AGENDA PLANNING AND ZONING MEETING Norwalk City Hall, 705 North Ave Monday, October 24, 2016 5:45 P.M.

CITY OF NORWALK REPORT TO THE NORWALK PLANNING COMMISSION

Preliminary Plat of the Warrior Run Estates Plat 2

CITY OF NORWALK REPORT TO THE NORWALK PLANNING COMMISSION

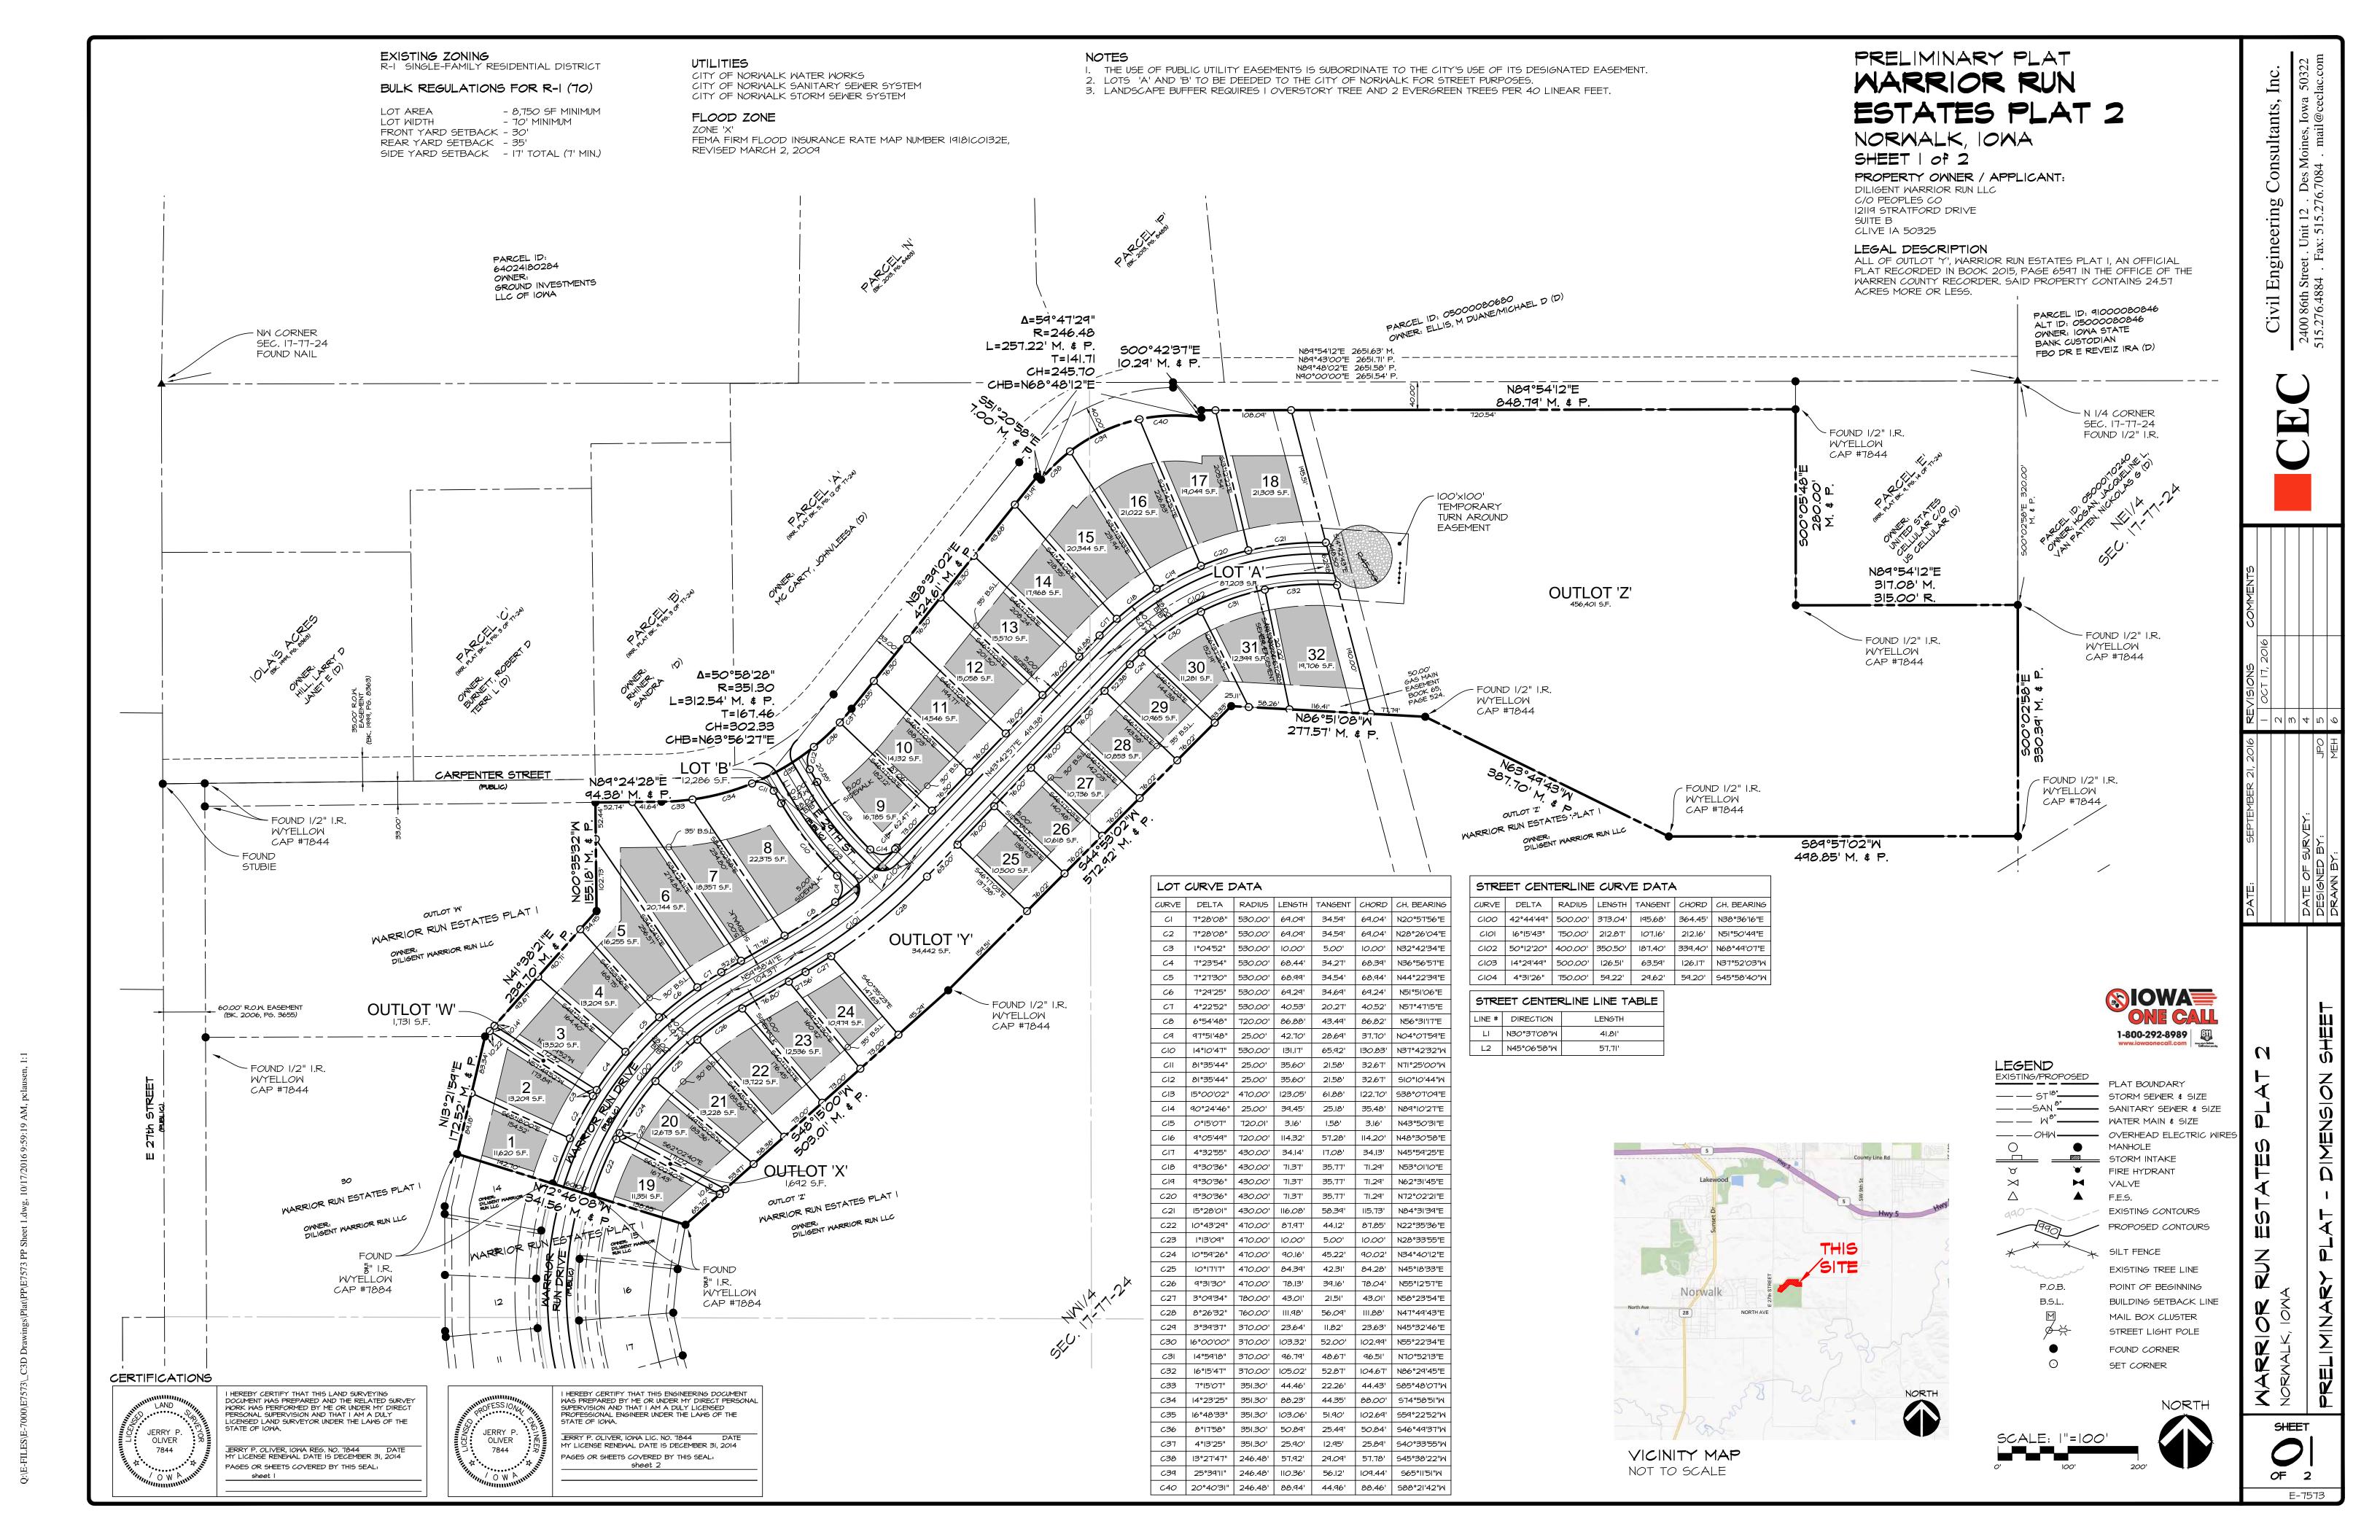
The subdivision ordinance requires 783 square feet of parkland per single family dwelling unit. The development has 32 lots and is required to provide 0.58 acres of parkland, or the equivalent per Subdivision Regulations, to the City. No park is shown on site.

Staff is working with the developer to discuss options for meeting the City's parkland dedication requirement.

Therefore, staff recommends that the request for the Preliminary Plat of Warrior Run Estates Plat 2 be approved with the following conditions:

- That the applicant provides all supporting documentation required within the Norwalk Subdivision Regulations.
- That any significant modifications to the final plat be reviewed and approved by the Planning & Zoning Commission and City Council.

EAST ELEVATION

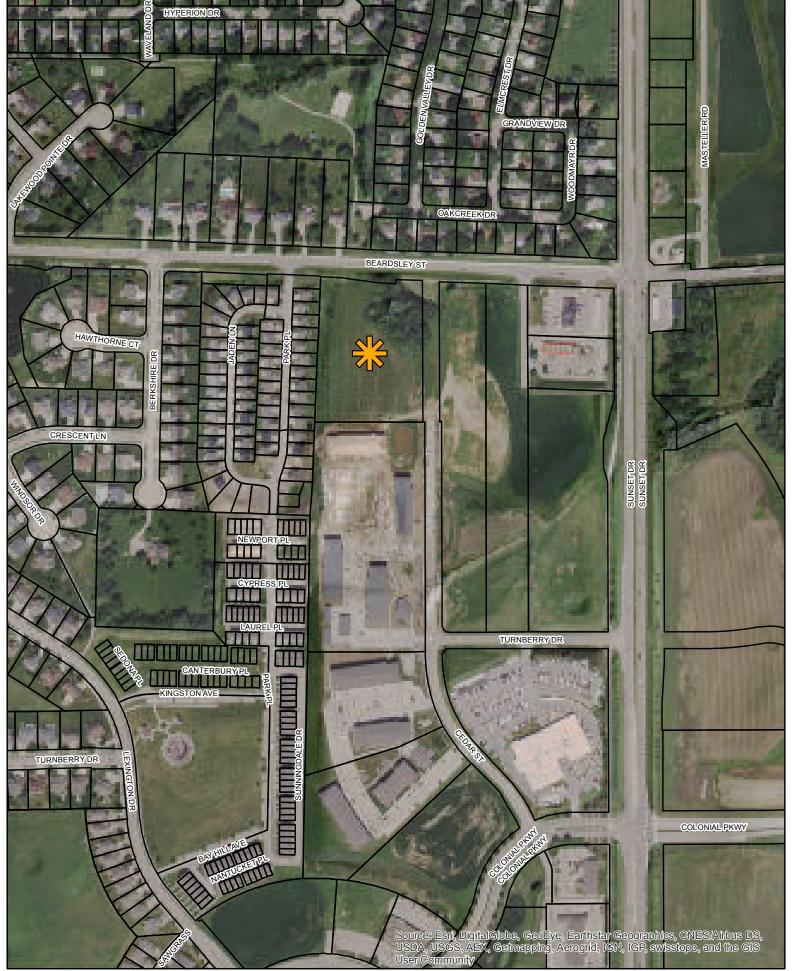
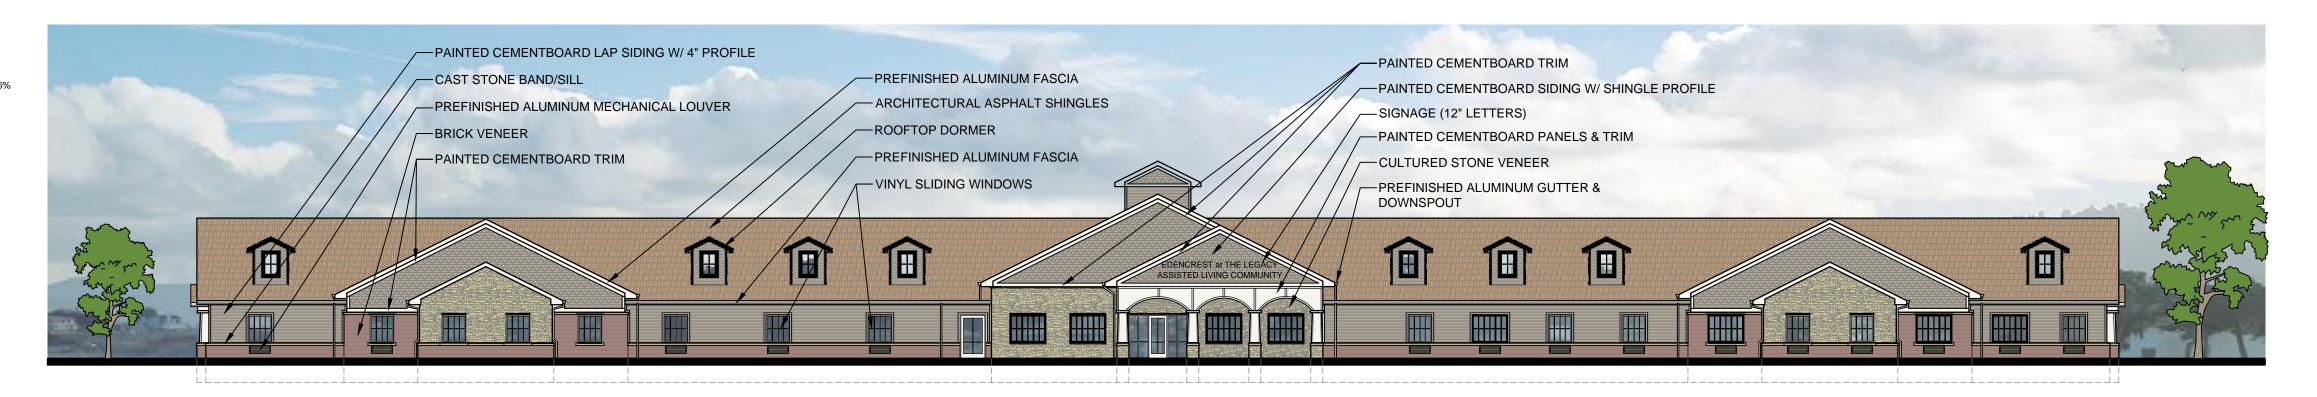
- The east elevation includes 47% class 1 and class 2 materials and exceeds the code requirement.
- The west elevation includes 39% class 1 and class 2 materials and is slightly below the code requirement.
- The north and south elevations include 29% class 1 and class 2 materials and is below the code requirement.

When the PUD master plan amendment was submitted the developer included building elevations that they wanted adopted with the master plan amendment as a formal piece of the Legacy PUD. Staff review of the PUD amendment ordinance is inconclusive as to whether the building elevations were adopted as part of the PUD or not.

It is staff opinion that the architectural standards are in place to ensure quality, long lasting buildings with a cohesive design in the City of Norwalk. The staffs review of the building elevations finds that the design is cohesive across all facades and that the design is not attempting to utilize lesser materials. It is staff opinion that the design meets the general intent of the architectural standards.

Overall the site plan meets or exceeds the City's requirements for development of a R-4 Assisted Living Facility. As noted, certain building facades do not meet the specific required percentages for building materials. The developer is of the opinion that the PUD amendment locked in the building design via the elevations provided with the amendment. The intent of the City's architectural standards is to ensure longlasting quality buildings are built in the City. It is the staff's opinion that the proposed design meets that intent.
